ENGINE - FUEL AND CONTROL - FUEL AND CONTROL - INCORPORATE A RECONTOURED P2/T2 AIR TUBE
ASSEMBLY - CATEGORY CODE 6 - MOD.ENG-73-0010

V2500-ENG-73-0010

SERVICE BULLETIN

The P2/T2 air tube and the clipping details - After details Fig.2

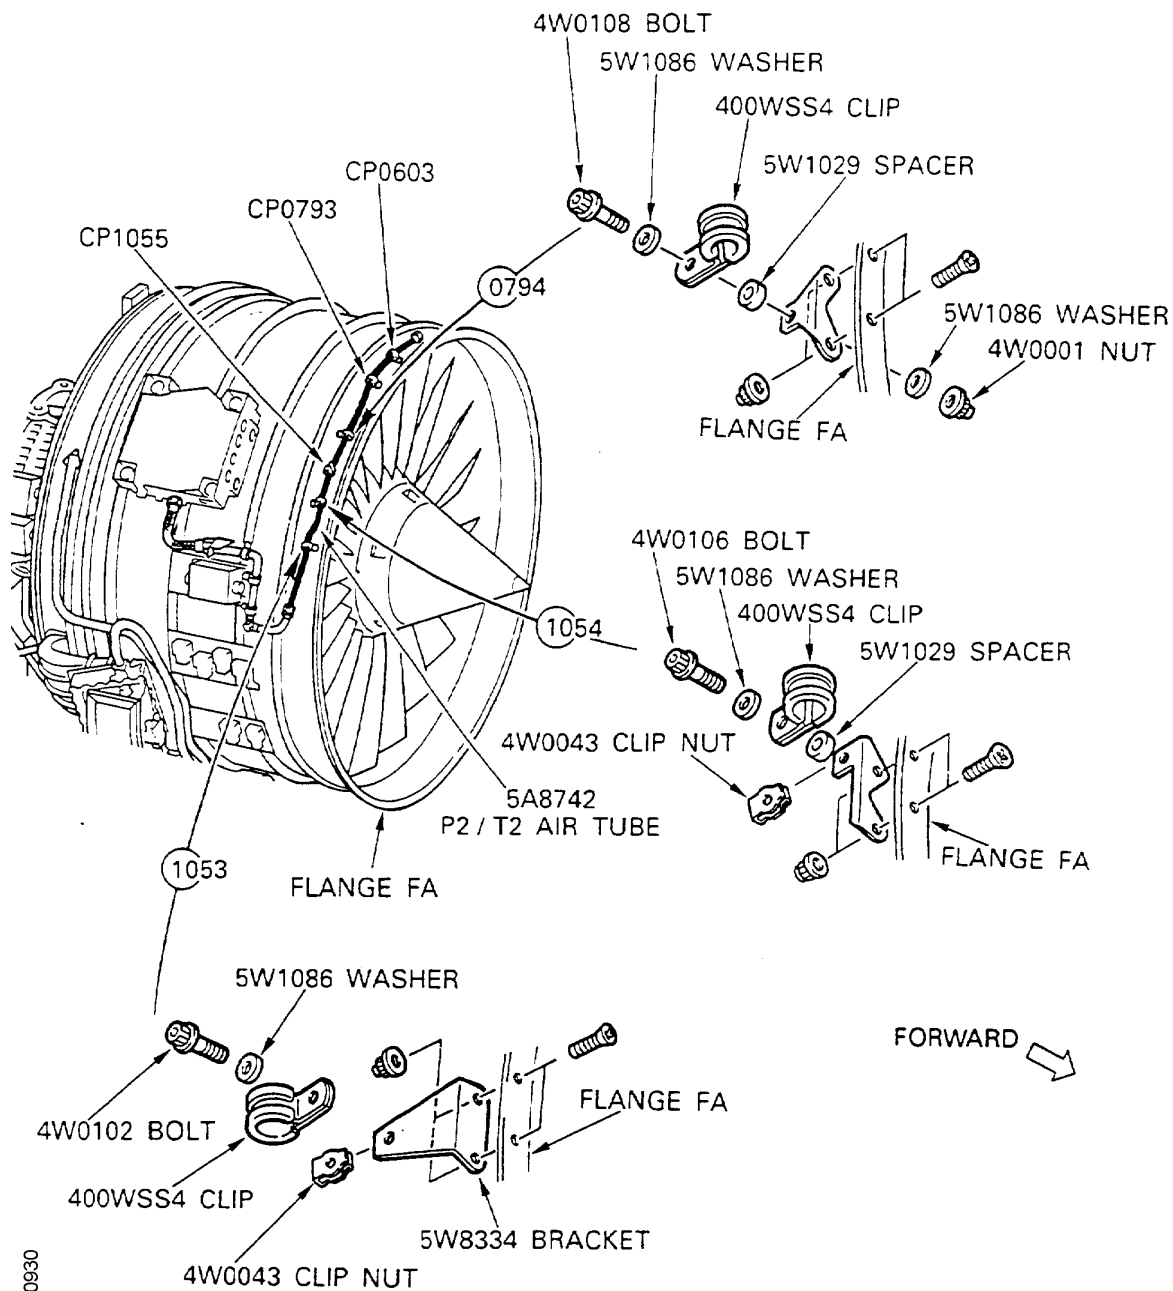
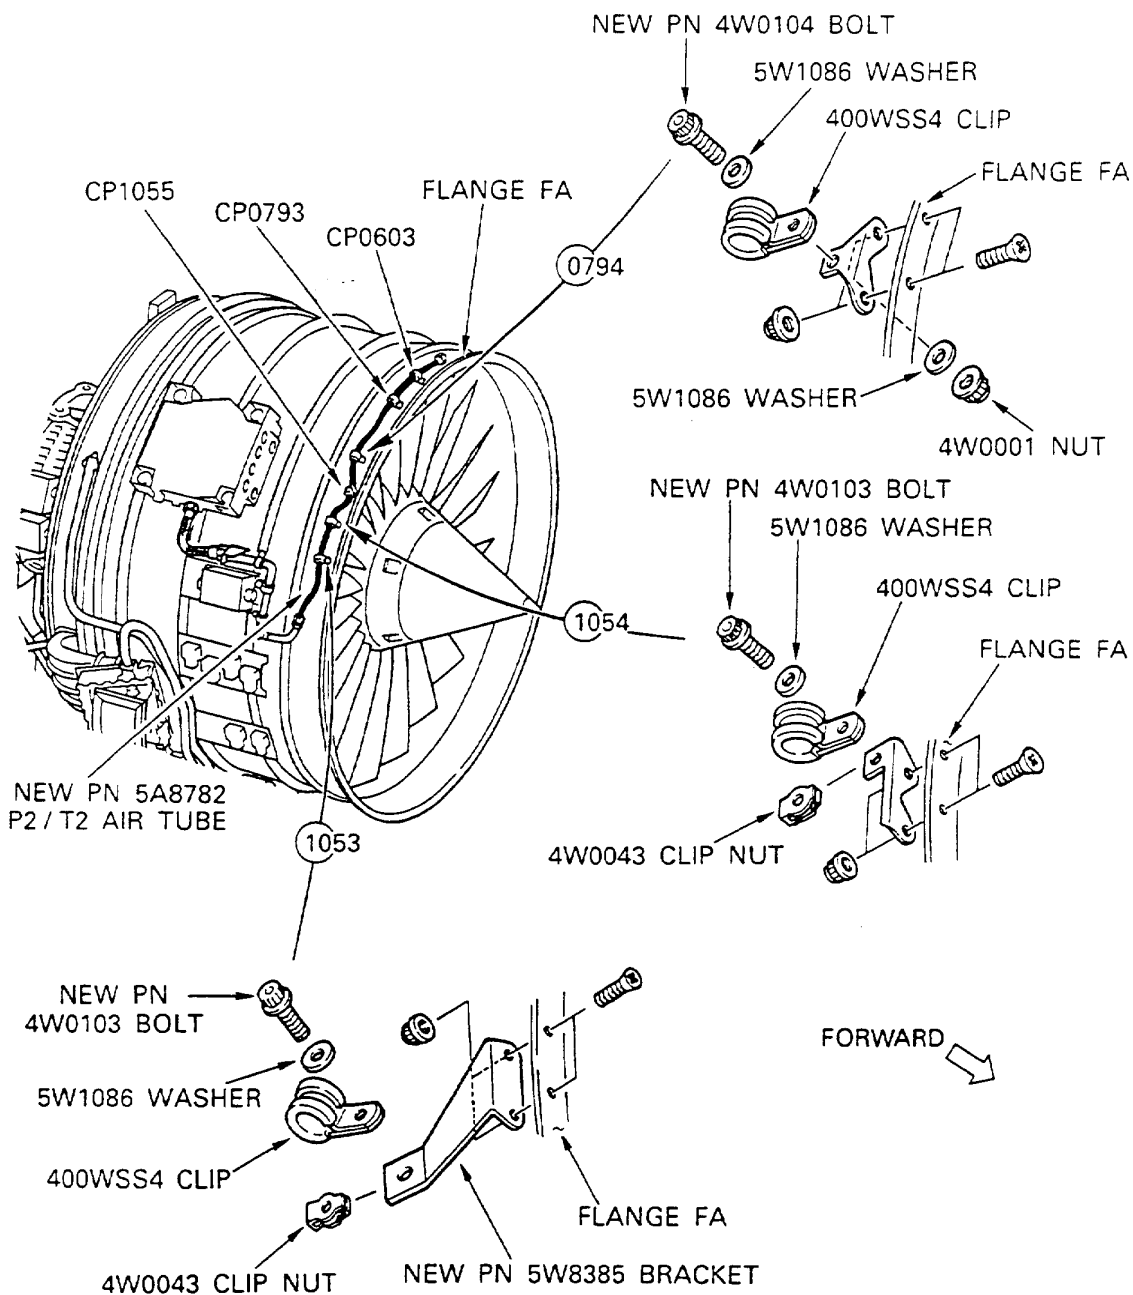
- (1) The changes introduced by this Service Bulletin are as follows: (See Figures 1 and 2).
- (a) The P2/T2 Air Tube is re-routed to get sufficient clearance between the Tube and the Flange FA.

- (b) The Bracket which supports the P2/T2 Air Tube at CP1053 is changed in its shape and also the stock thickness is increased from 0.047 in (1,20 mm) to 0.063 in. (1,60 mm) to clear the resonance with new P2/T2 Air Tube.

- (c) At CP0794 and CP1054, each of 5W1029, Spacers has been deleted and the clip locations are tuned rearwards.
 - (d) At CP0794, the Bolt is changed to shorter bolt from the existing 4W0108 to the new 4W0104.

- (e) At CP1054, the Bolt is changed to shorter bolt form the existing 4W0106 to the new 4W0103.
 - (f) At CP1053, the Bolt is changed to longer bolt from the existing 4W0102 to the new 4W0103 in line with an installation of the new thickened bracket.

- (1) Install the new 5W8385, Bracket, to the Flange FA by the approved procedures in the Engine Manual, 72-00-32, Installation, TASK 72-00-32-420-001. (Refer to Figure 2, and 1.K.(2)).

- (2) Install the new 5A8782, P2/T2 Air Tube to the Module by the approved procedures in the Engine Manual, 72-00-32, Installation, TASK 72-00-32-420-003. (Refer to Figure 2, and 1.K.(2)).

- (3) At CP0794, install the new 4W0104, Bolt, the two 5W1086, Washers, 400WSS4, Clip, and 4W0001, Nut, to the new Tube and the Bracket with a new clipping configuration. Torque the Nut to 36 - 45 lbin. (4,00 - 5,00 Nm). (Refer to Figure 2, and 1.K.(3)).

- (4) At CP1054, install the new 4W0103, Bolt, 5W1086, Washer, 400WSS4, Clip, and 4W0043, Clip Nut, to the new Tube and the Bracket. Torque the Bolt to 36 - 45 lbfin. (4,00 - 5,00 Nm). (Refer to Figure 2, and 1.K.(3)).

- (5) At CP1053, install the new 4W0103, Bolt, 5W1086, Washer, 400WSS4, Clip, and 4W0043, Clip Nut to the new Tube and the new Bracket. Torque the Bolt to 36 - 45 lbfin (4,00 - 5,00 Nm). (Refer to Figure 2, and 1.K.(3)).
